From: [Nicholas Davies](#)
To: [Urban Design Comments](#)
Cc: schehak@madison.k12.wi.us; sbowersox@opnarchitects.com
Subject: No to child drive-thrus at Toki / Orchard Ridge (93015)
Date: Tuesday, May 19, 2026 7:30:56 PM

From: [Austin Griesbach](#)
To: [Luecke, Kevin C](#); [Safe Streets](#); [Urban Design Comments](#); [Figueroa Cole, Yannette](#)
Subject: MMSD School Design and Complete Green Streets
Date: Tuesday, May 19, 2026 9:43:23 AM
Attachments: [2026-05-19_Madison_Vision_Zero_Progress.png](#)
[image.png](#)

MMSD REF 24: Akira Toki MS - Orchard Ridge ES
OPN Architects | JSD Inc.

UDC Informational

Site Plan

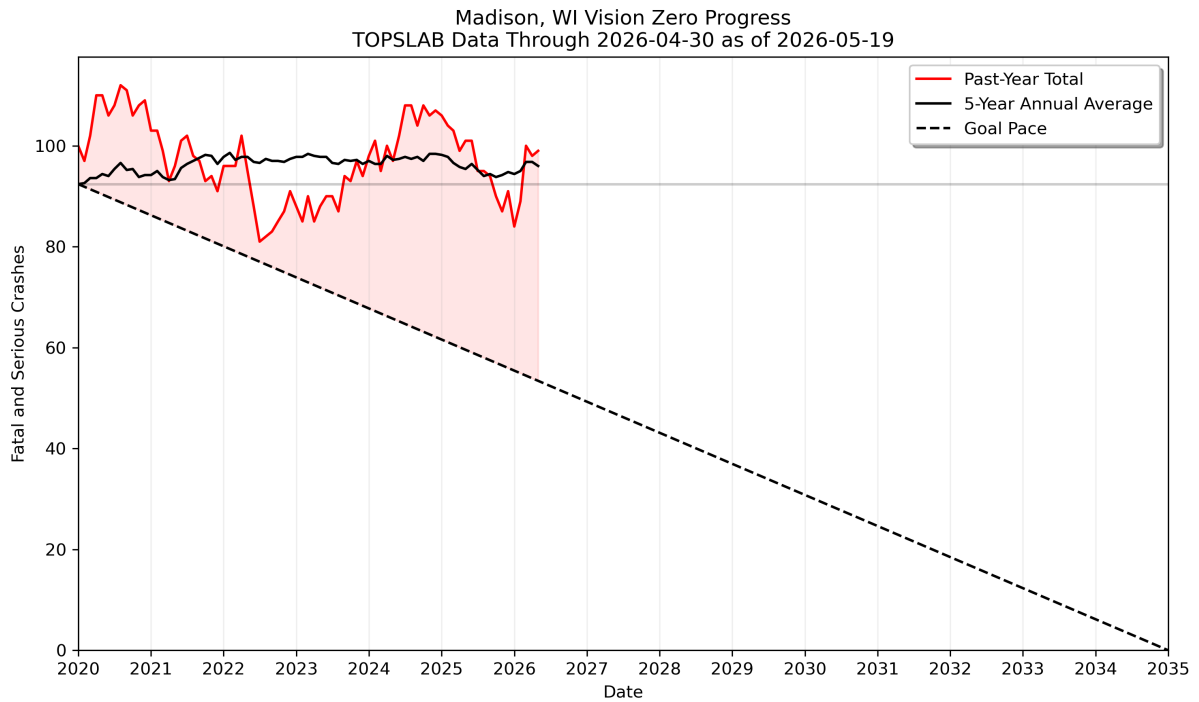
The design calls for a major drop-off loop off of Gilbert Road. Not only will this substantially increase the level of traffic on Gilbert Road, it will also likely increase the level of traffic on Russett Road (where a kid was hit by a driver recently) as drivers cut over to Gilbert from Whitney.

I am worried that this will harm City-wide bike connectivity, as well as kids' access to their own school by bike. Gilbert Road was on the original All Ages and Abilities bike network, and remained on the network in the recent draft comment period. Taking Complete Green Streets at its word, Gilbert Road should really be a bike boulevard with motor vehicle volume kept as low as possible.

used to reduce the prevailing speed to 20 mph or less and to keep ADT low (max ADT on a bicycle boulevard is 3,000; 1,000 if transit route)". This council-adopted City policy seems wholly incompatible with a major driveway loop like this on Gilbert. I think the driveway design will harm the City's ability to stand by its policy commitments and achieve the Vision Zero goal.
